ADDENDUM NO. 2

**Three Rivers Community Schools – Three Rivers Middle School Additions and
Renovation**

SHEET CLARIFICATIONS / REVISIONS

UNIT 'A' MECHANICAL PIPING PLAN

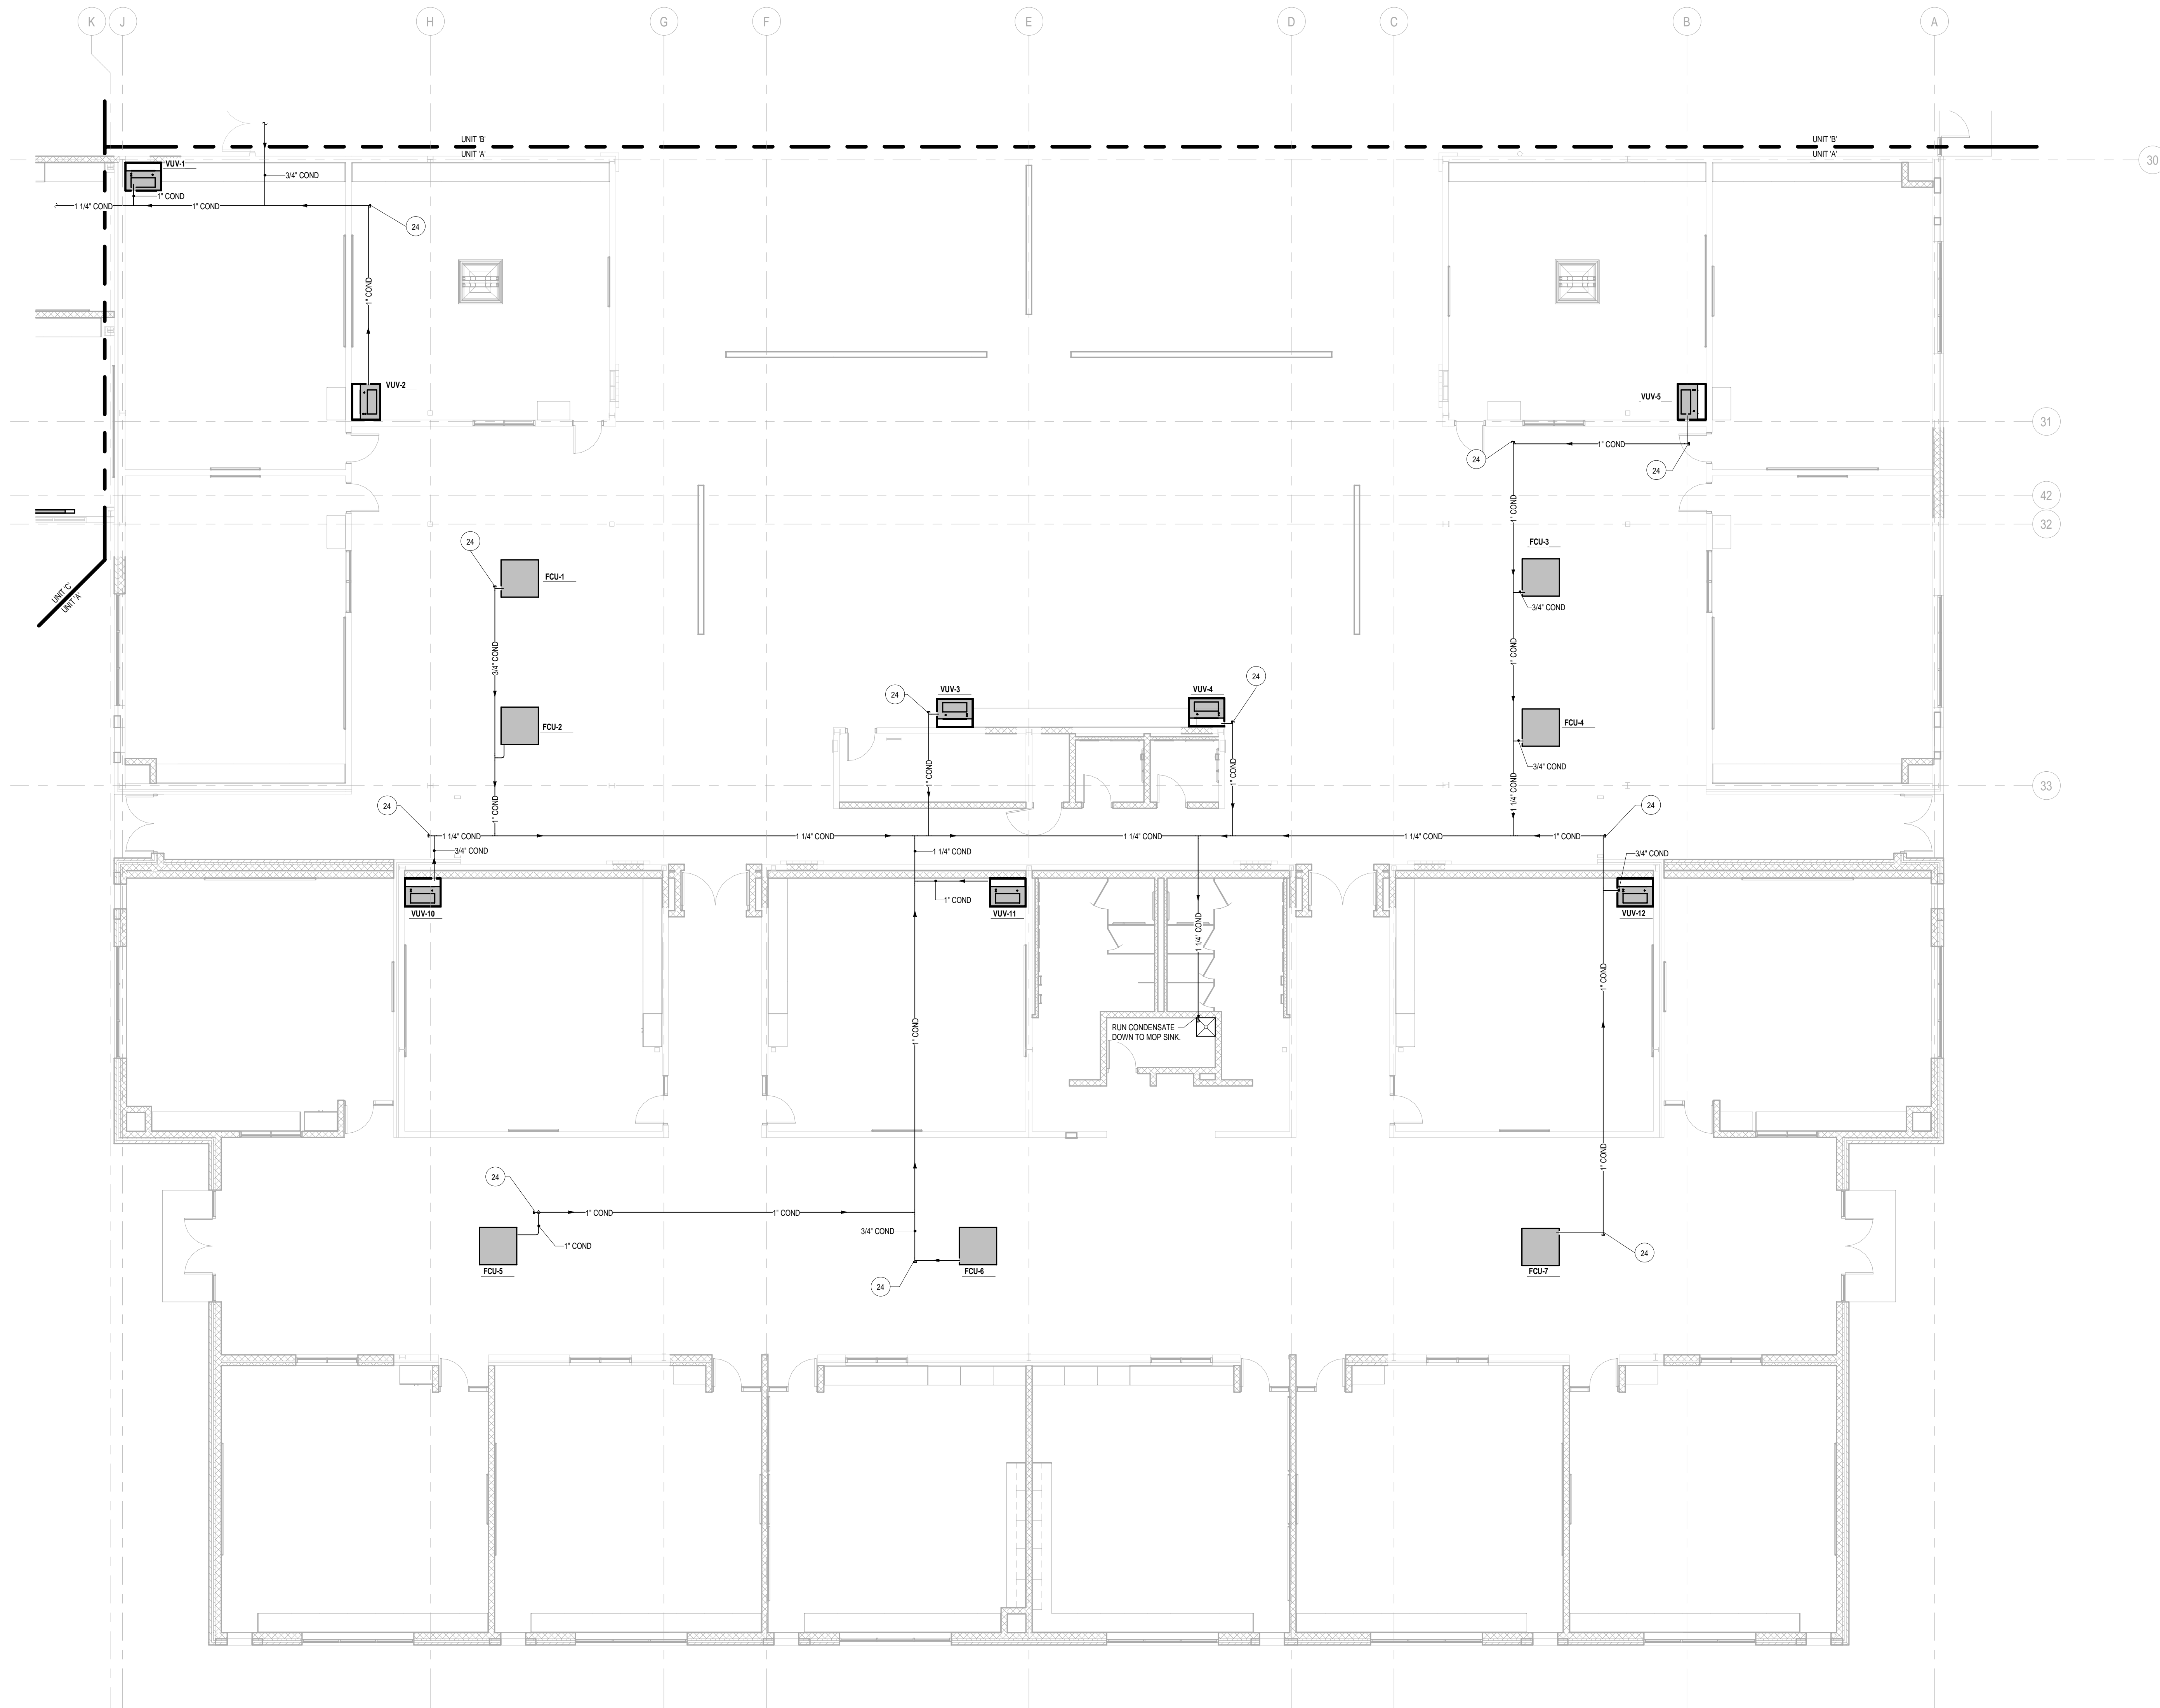
ITEM NO. 44 SHEET M4.1A UNIT 'A' MECHANICAL PIPING PLAN (NEW)

New sheet to show gas piping and condensate piping.

UNIT 'C' MECHANICAL PIPING PLAN
1/8" = 1'-0"

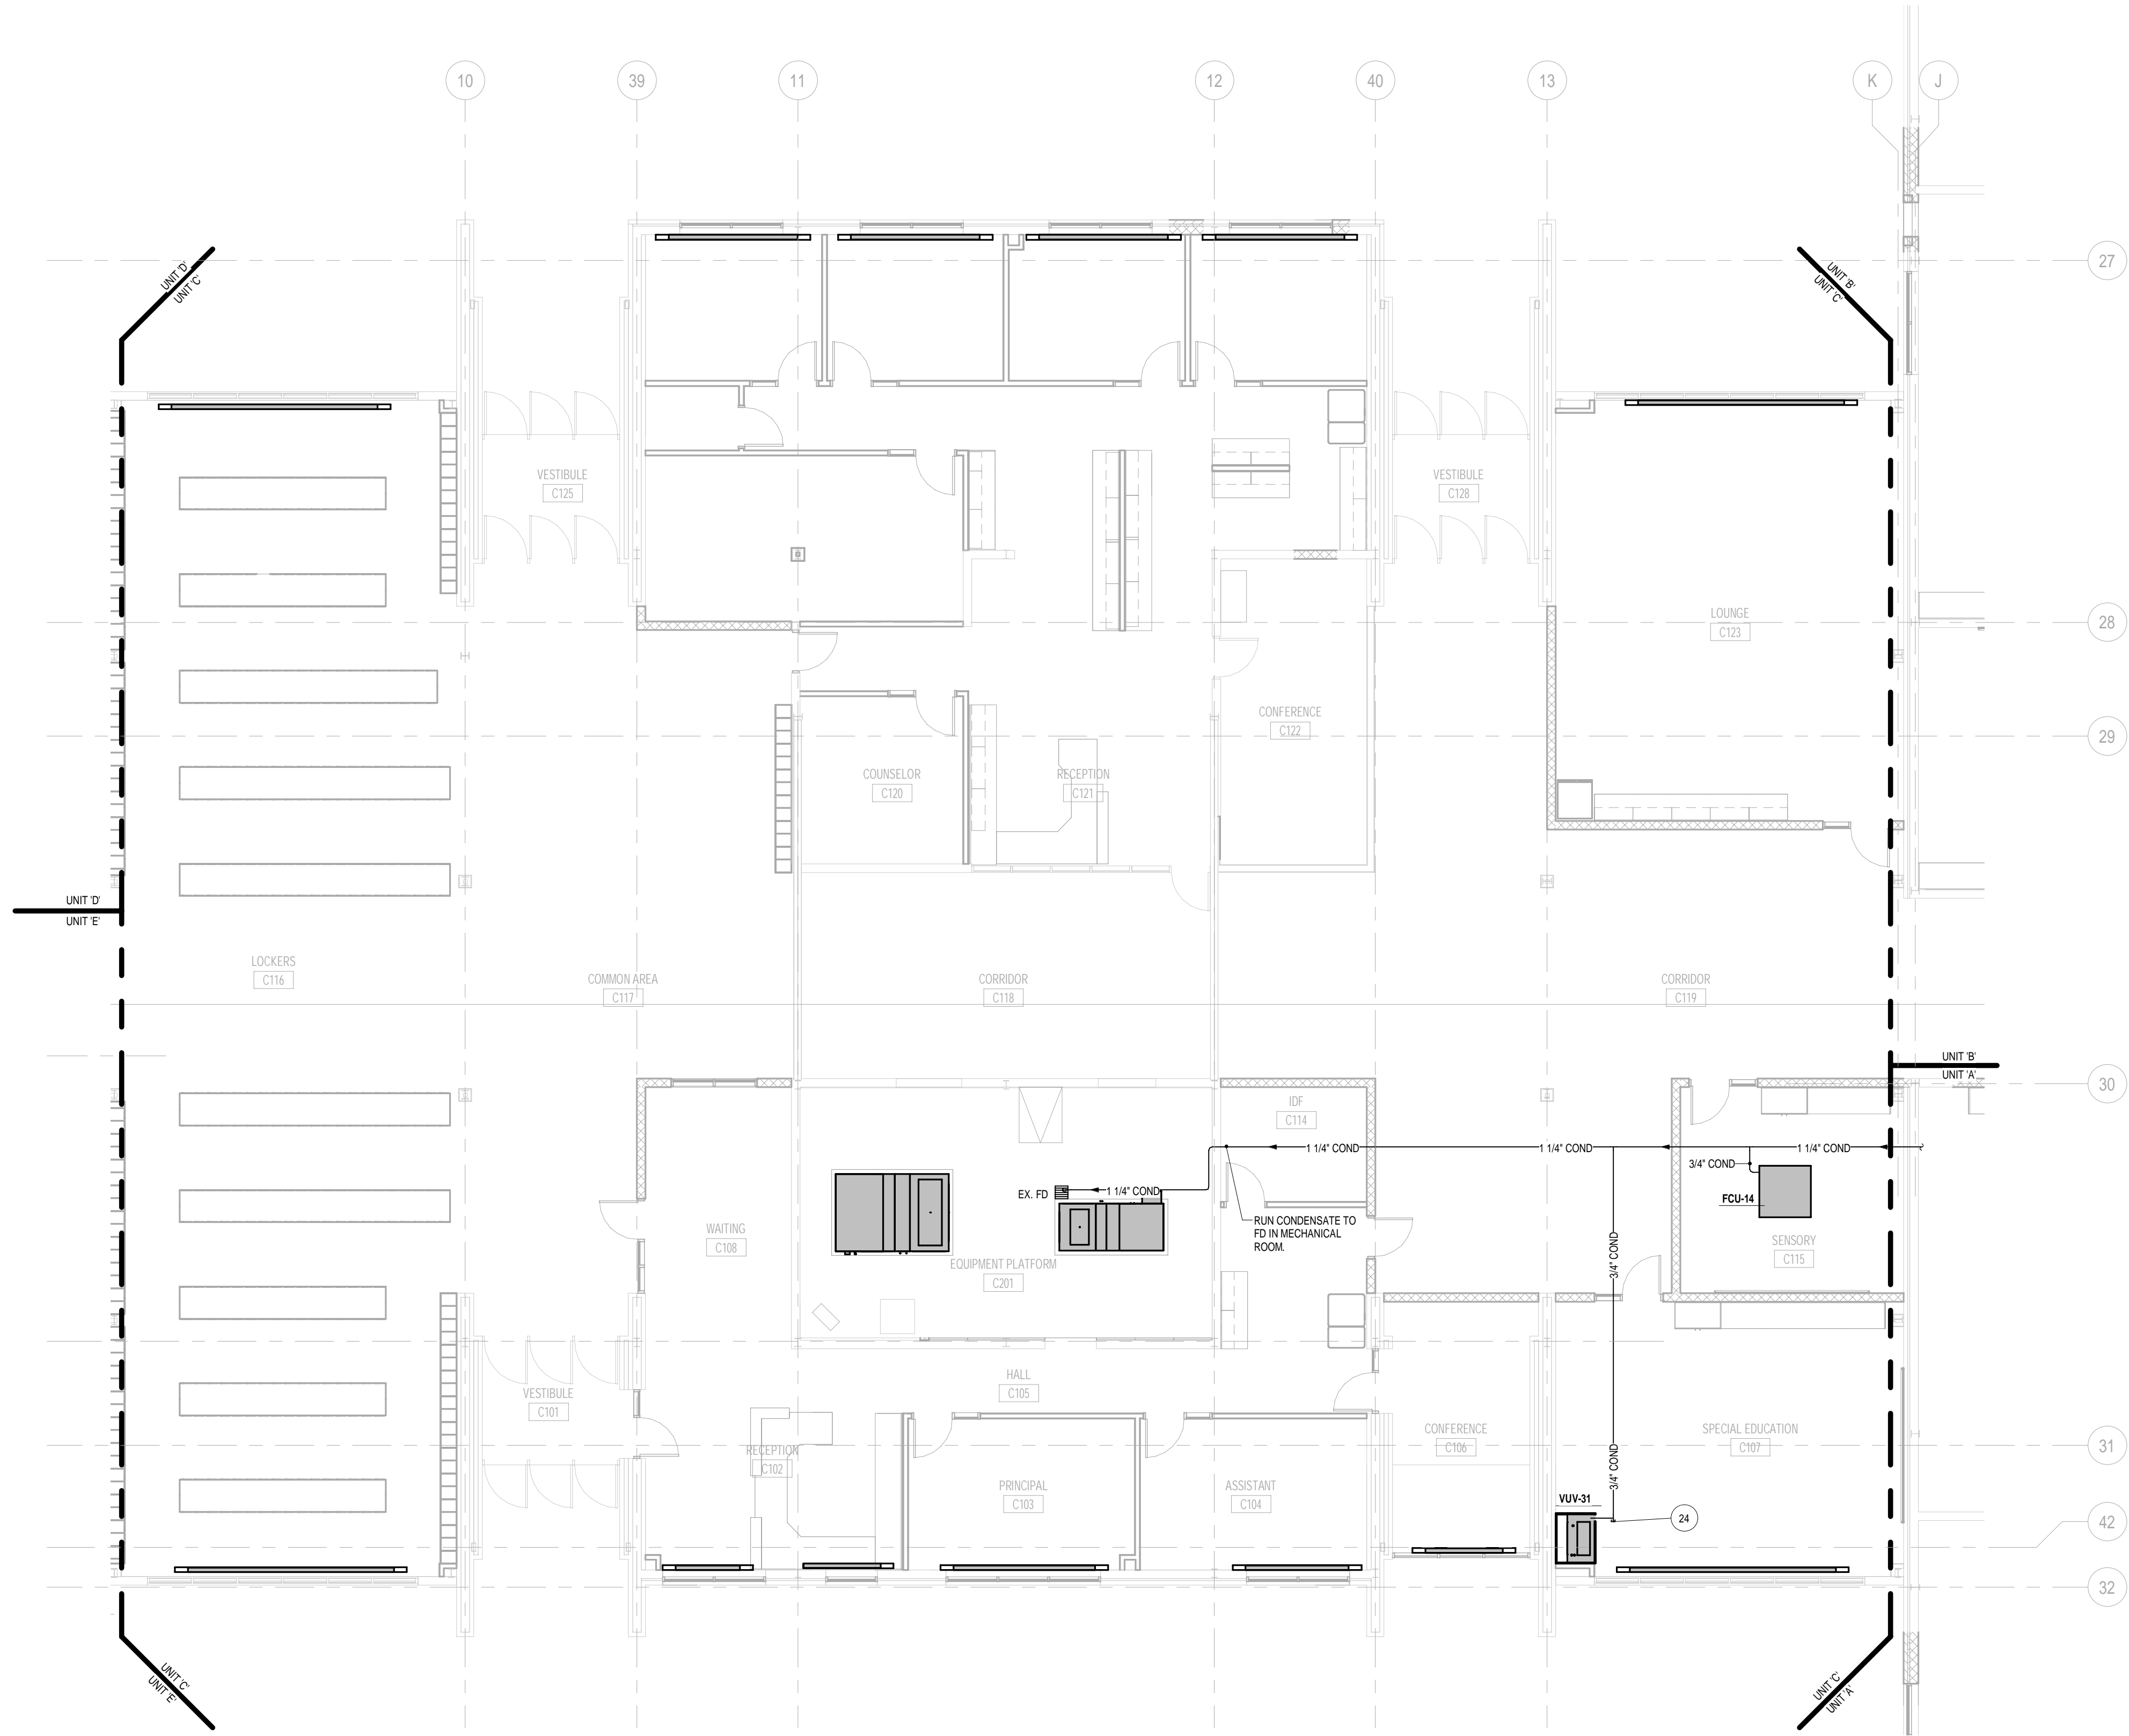
ITEM NO. 46 SHEET M4.1C UNIT 'C' MECHANICAL PIPING PLAN (NEW)

New sheet to show gas piping and condensate piping.
